CITY OF KELOWNA
MEMORANDUM

APPLICATION NO. DP07-0050 **OWNER:** Dale Charles Forsythe
AT: 200 and 225 Rutland Road **APPLICANT:** Protech Consultants Ltd.

PURPOSE: TO CONSTRUCT A NEW FOUR STOREY MIXED-USE
COMMERCIAL/RESIDENTIAL BUILDING ON THE SUBJECT
PROPERTIES

Elevation at Entrance
SCALE: 1/4" = 1'-0"

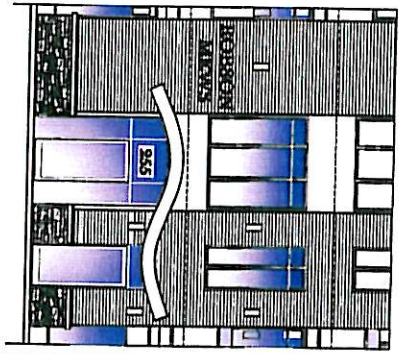
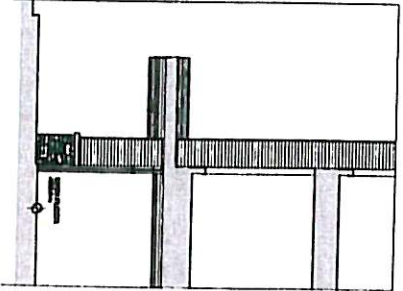
The APC noted that on the whole they support canopies which extend above public property provided they do not pose a safety hazard.

Spatial separation calculations required for north elevation and partial east elevation, possible non-conformance to building code. Dead end corridor on two residential floor levels at south end of floor area. Front entrance canopy encroaches on public property.
